Docket Item # 3
BAR CASE # 2013-00118

BAR Meeting
May 15, 2013

ISSUE: Alterations (Window Replacement)

LOCATION: 1211 Michigan Court

Figure 6: Traditional Wood Muntin vs Aluminum-Clad Muntin “Putty” Profiles

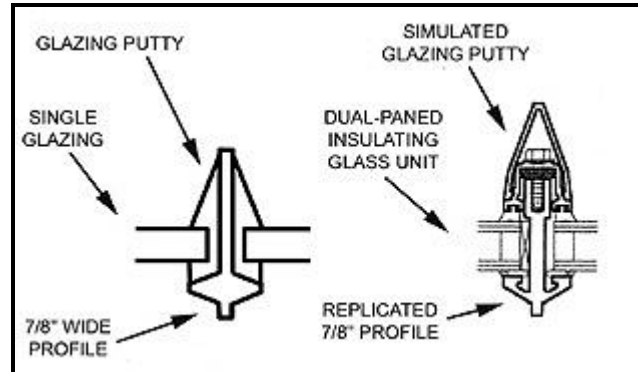
With respect to window materials, the *Window Policy* states: “High quality, appropriately detailed aluminum clad wood replacement windows may be used on buildings constructed after **1969**, when these windows became commercially available.” Subsequently, at a meeting in 2012, the Board amended its *Window Policy* to also permit the use of “Anderson Fibrex windows or a similar quality, paintable wood composite [or fiberglass] windows on buildings constructed after **1975**.” The *Policy* also specifically identifies that “vinyl or vinyl clad windows are not considered appropriate or compatible” and that “muntins must be paintable and have a putty glaze profile on the exterior. The subject vinyl windows have a flat applied muntin.

Figure 7: Detail of Installed Vinyl Window Muntins

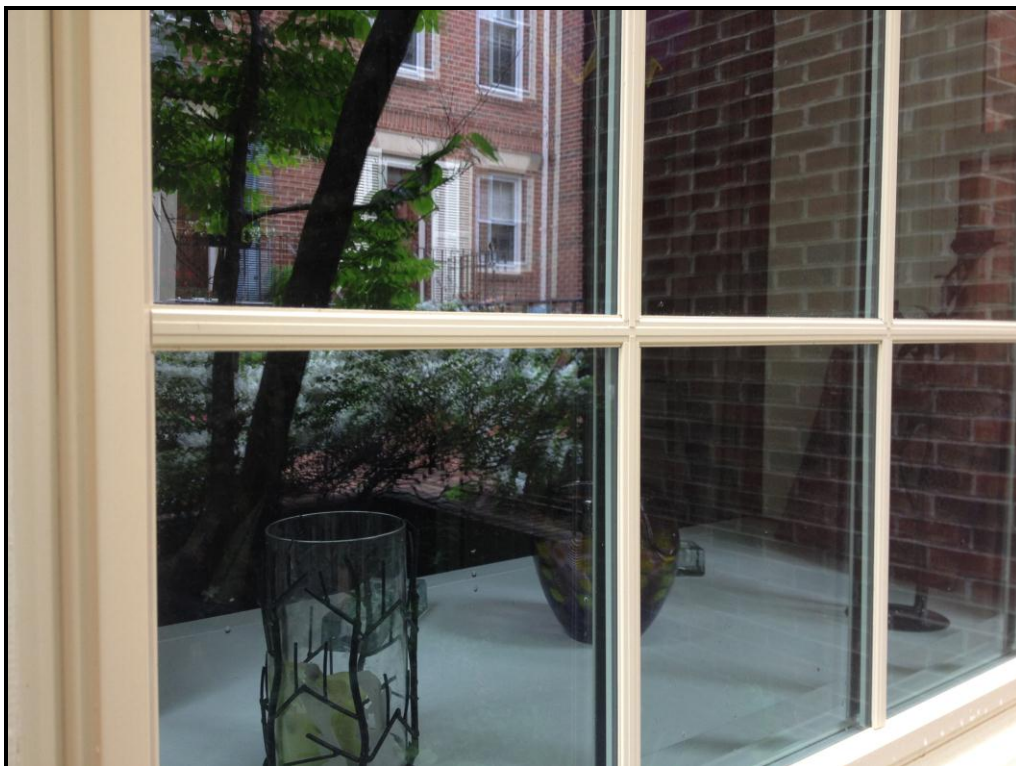
Based on the material (vinyl), the use of an insert window with wide surrounding trim and the flat muntin profile, Staff finds that the windows installed on do not comply with the Board's *Window Policy*. Staff recommends that the Board deny this Certificate of Appropriateness application, require removal of the inappropriate vinyl windows and require replacement with new fiberglass, wood composite or aluminum clad wood windows which comply with the Board's *Window Policy* and the Alexandria Replacement Window Performance Specifications.

Staff recommends denial of the Certificate of Appropriateness application for vinyl windows and, instead, recommends replacement with new fiberglass, wood composite or aluminum clad wood windows which comply with the Board's *Window Policy* and the Alexandria Replacement Window Performance Specifications.
